SEWAGE DISPOSAL SYSTEM

MARYLAND STATE DEPARTMENT OF HEALTH DISTRICT _____

SUBDIVISION Countryside ROAD # 3651 Point Hitch Rd LOT 16

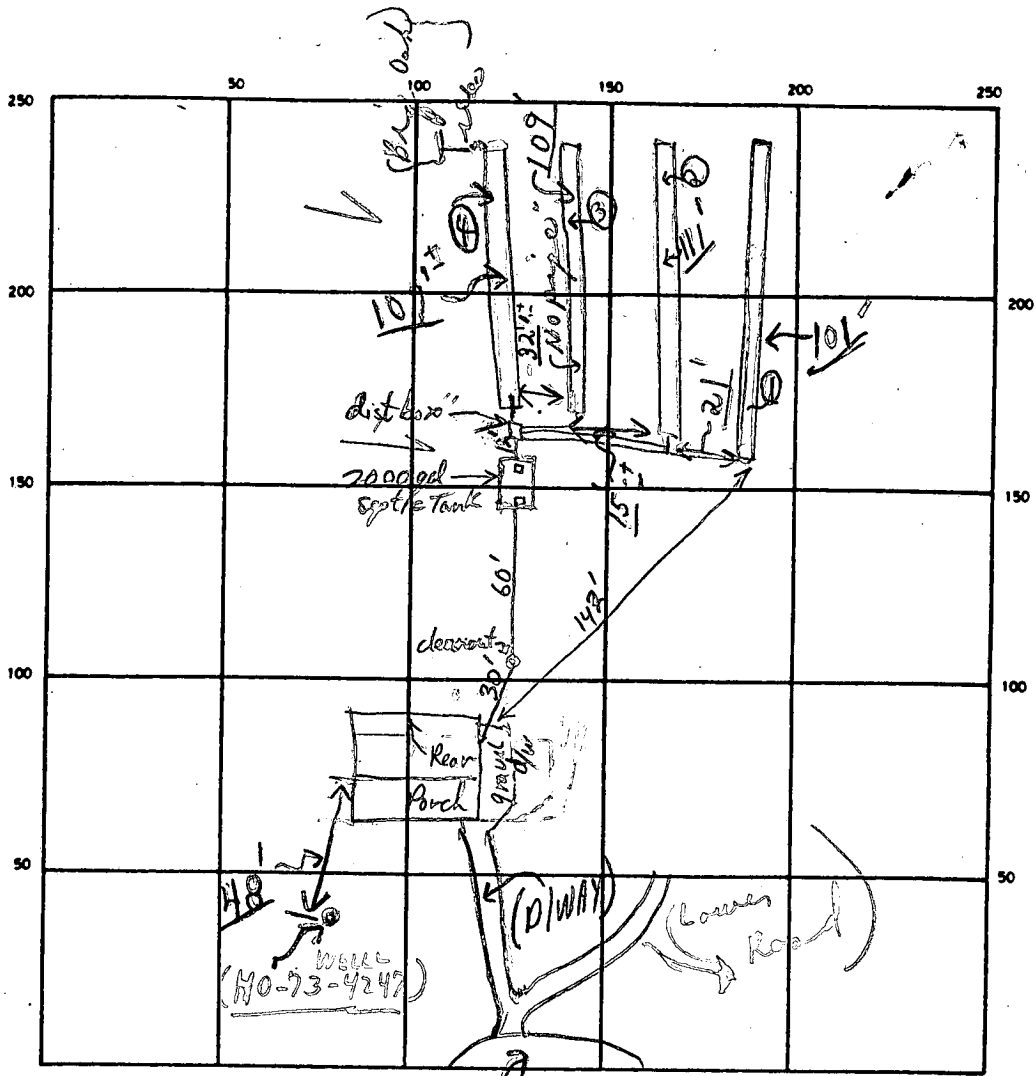
REMARKS P.M. 10/29/91 Partial-on trenches only - ok for stone in all trenches; need to see all pipes from house to trenches; and pipe each of the trenches at ends & middle. "No other work done"; "HOLD FOR A CALL", C.B.S. C.B.S.

Tank & db installed OK - out over 12/23/91
